Donald C. Cook Nuclear Plant Unit 2
Response to Request for Additional Information Regarding Proposed Alternative to
the American Society of Mechanical Engineers Code, Section XI
Repair Requirements

10 CFR 50.55a Request Number ISIR-4-06

Response to Request for Additional Information on Proposed Alternative in Accordance with 10 CFR 50.55a(a)(3)(ii) Hardship or Unusual Difficulty without Compensating Increase in Level of Quality or Safety

Sketch of FW-17 Socket Weld

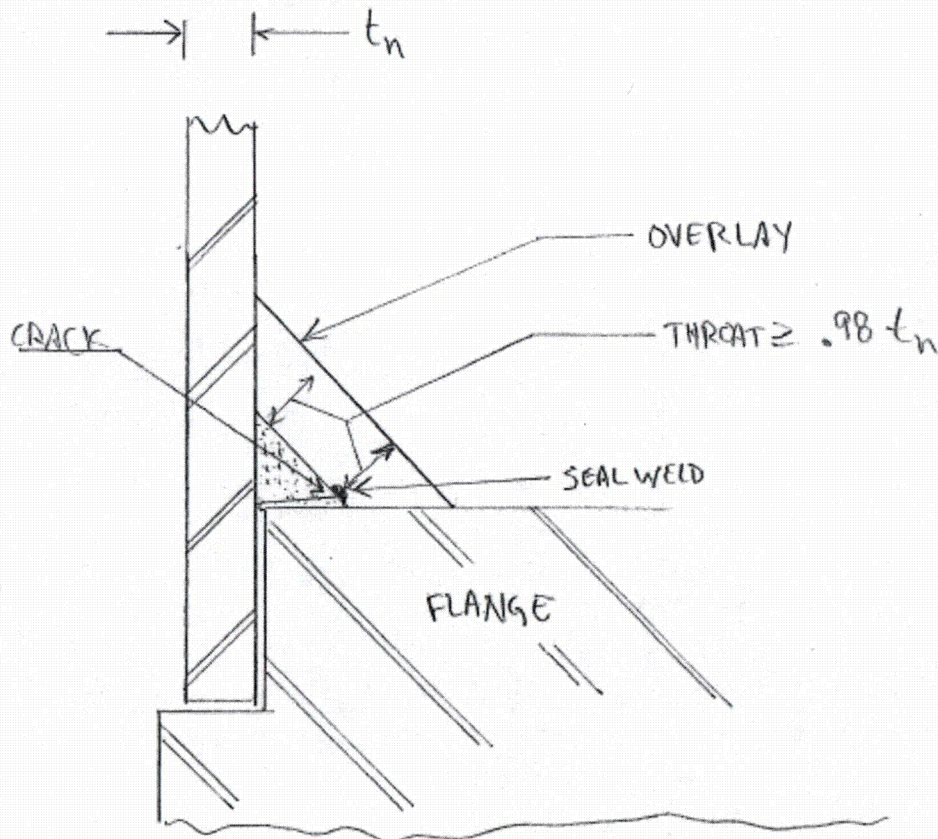
Item C-1 (two drawings on left) are slip-on flanges. Item C-2 (single drawing on right) is flange socket weld. Item C-3 is another socket weld. The August 23, 2015, application indicates the affected component is socket weld FW-17. However, based on the attached drawings, the drawing supplied in Section 7 of your application does not clearly represent a socket weld. This, at the very least, indicates that I&M may require two alternatives from the code case: 1) a mechanism other than fatigue, and 2) apply socket weld code case to a weld that is not a socket weld.

Therefore, the NRC staff requires a better drawing of the subject component to clearly indicate if it is a slip-on flange or a socket weld flange. In other words, if this is a socket weld then a better drawing is requested. If it is not a socket weld, then you need to revise your request to reflect that the weld in question is not a socket weld and provide further discussion regarding that alternative to the code case.

Below is a revised sketch of the socket weld arrangement and proposed weld overlay for CNP Unit 2 socket weld, FW-17. The sketch previously provided was intended to show a simplified sketch of the weld overlay itself and not the actual type of flange and existing weld arrangement. This revised sketch shows the actual flange and weld arrangement for socket weld FW-17 with the proposed weld overlay.
